TECHNICAL BULLETIN

429-18-58

MODEL AFFECTED: 429

SUBJECT: BELLCRANK ASSEMBLIES 429-001-523-101, 429-001-523-103, 429-001-532-101, AND 429-001-532-103, UPGRADE OF.

Figure 2 – Bellcrank Assembly Details

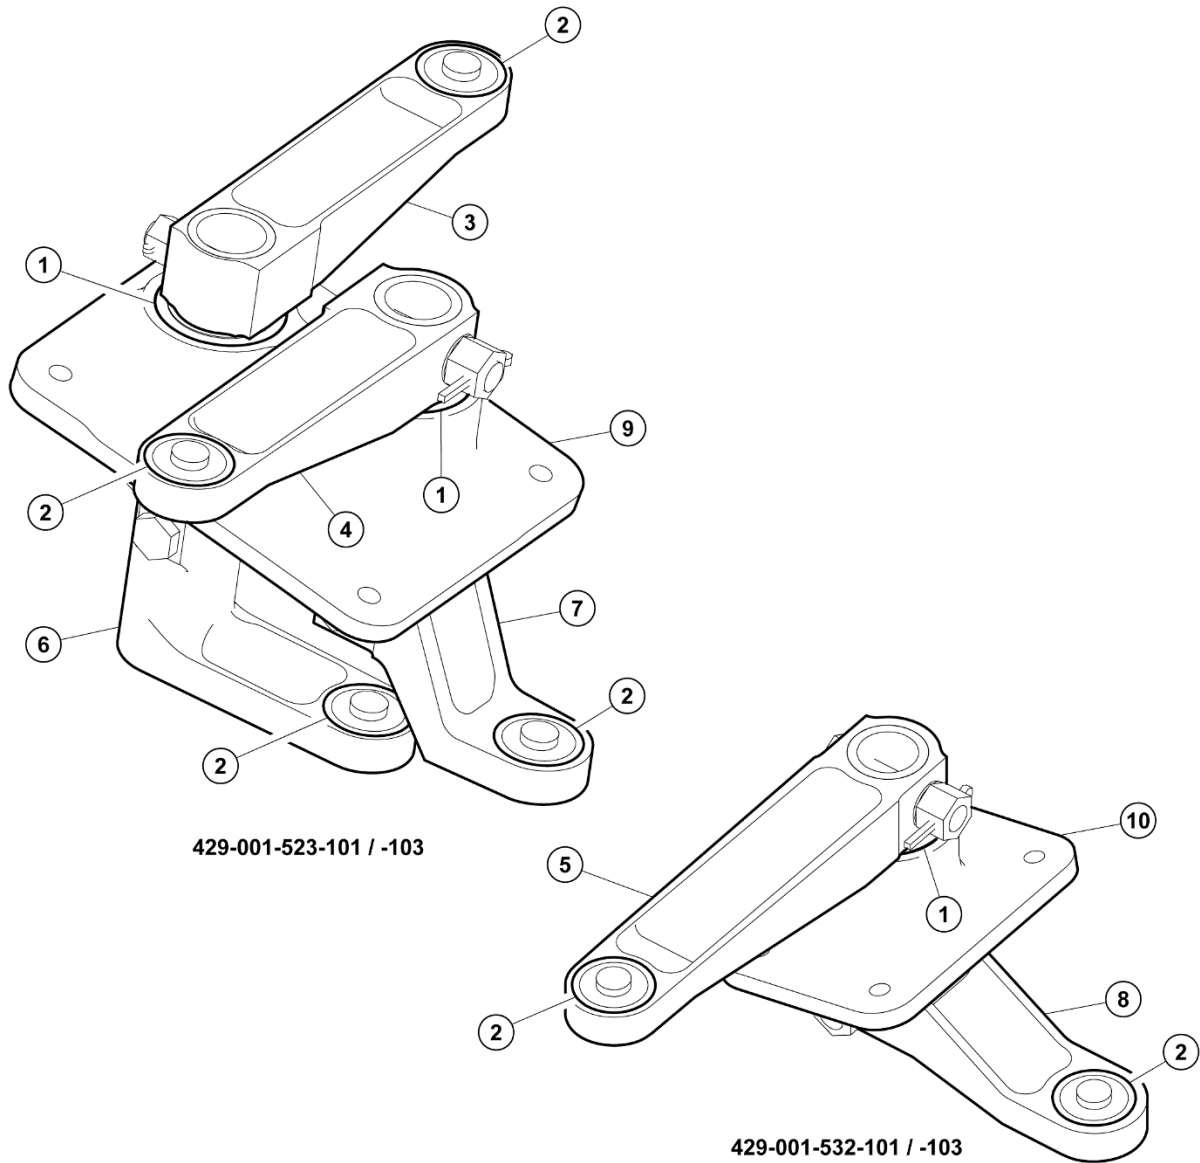
3. Disassemble the 429-001-523-101/-103 and 429-001-532-101/-103 roof mounted bellcrank assemblies.
4. Discard six MS27646-41 pivot bearings (1, Figure 2).
5. Remove and discard six MS27643-4 arm assembly bearings (2) and sleeves 120-13-4A (BHT-ALL-SPM).

Figure 3 - Bellcrank Assembly Details

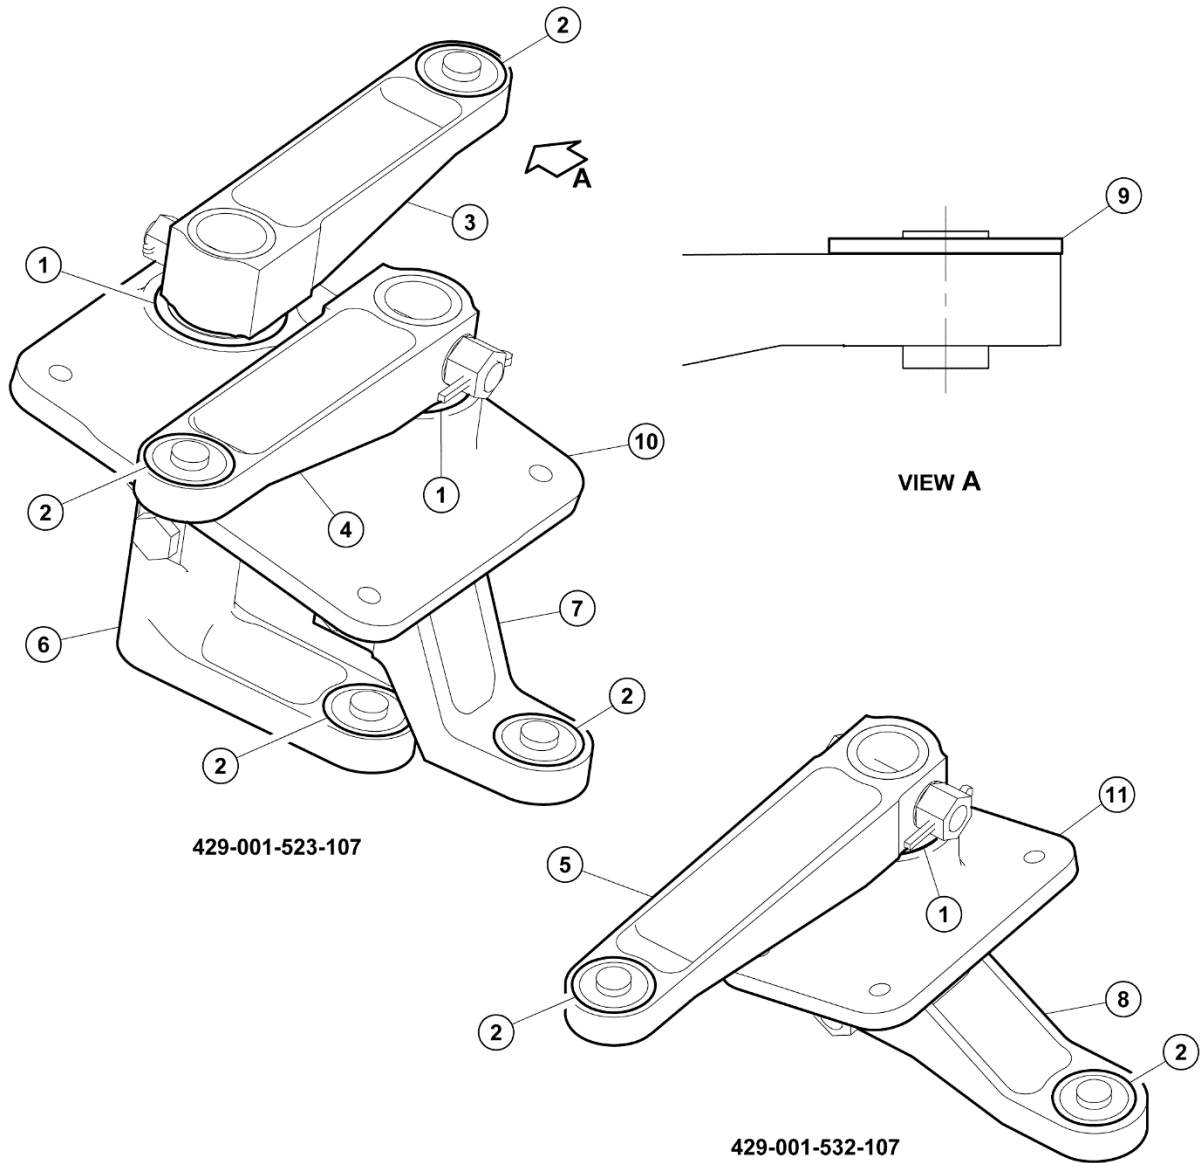
6. Install 120-13-4A sleeves and 429-301-012-101 bearings in the upper arm assemblies (3, 4, and 5) (BHT-ALL-SPM).
7. Lightly abrade the upper surface of the upper arms (3, 4, and 5) and bond 140-055A7 (9) washer to the upper surface of upper arms using adhesive (C-301). After adhesive cure, edge seal the washer using sealant (C-251)(Figure 3, View A).
